TAL-CO SUPPLEMENTAL INSTRUCTION #70			
CAFETERIA - ICE MACHINE & CLOSER PANEL			
Project Name:	RW TOMLINSON - NEW HEAD OFFICE		
Project Location:	100 CitiGate Drive, Ottawa, Ontario		
ARCH. SI #:	ASK 206	Issued By:	Farah Bano
STRUC. SI #:	N/A	Date Issued:	November 9, 2017
MECH. SI #:	N/A	Revision #:	N/A
ELEC. SI #:	N/A	Revision Date:	N/A

TITLE: CAFETERIA - ICE MACHINE & CLOSER PANEL

PROJECT:
TOMLINSON NEW BUILDING

ASK-206

ROOM 114 SOUTH ELEVATION

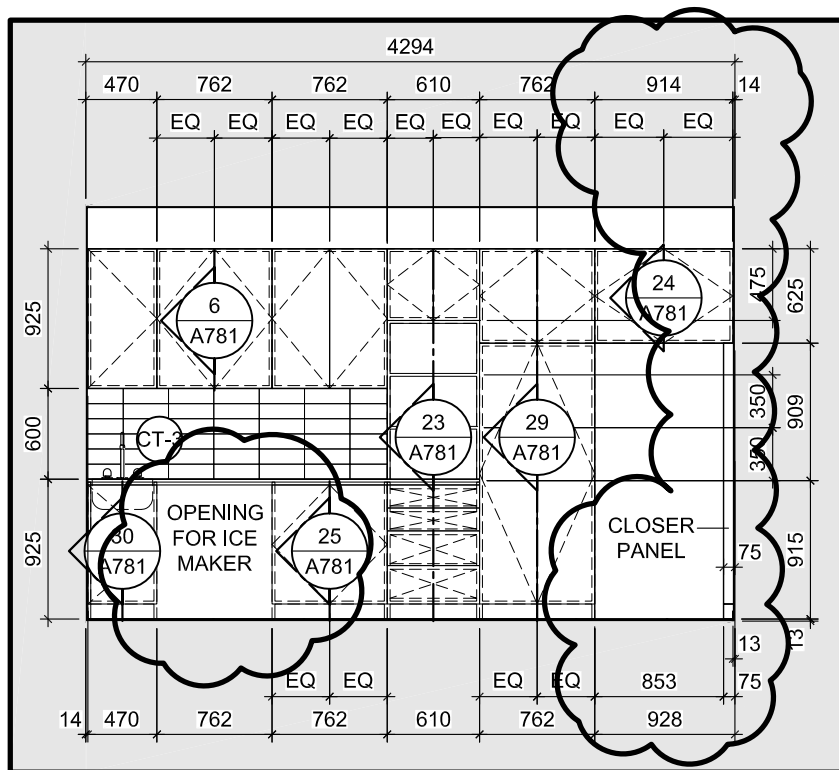
Millwork at Cafeteria revised to accommodate Ice Machine. Provide Electrical and Plumbing to Ice Machine as per cut sheet.
Closer Panel dimensions clarified as well.
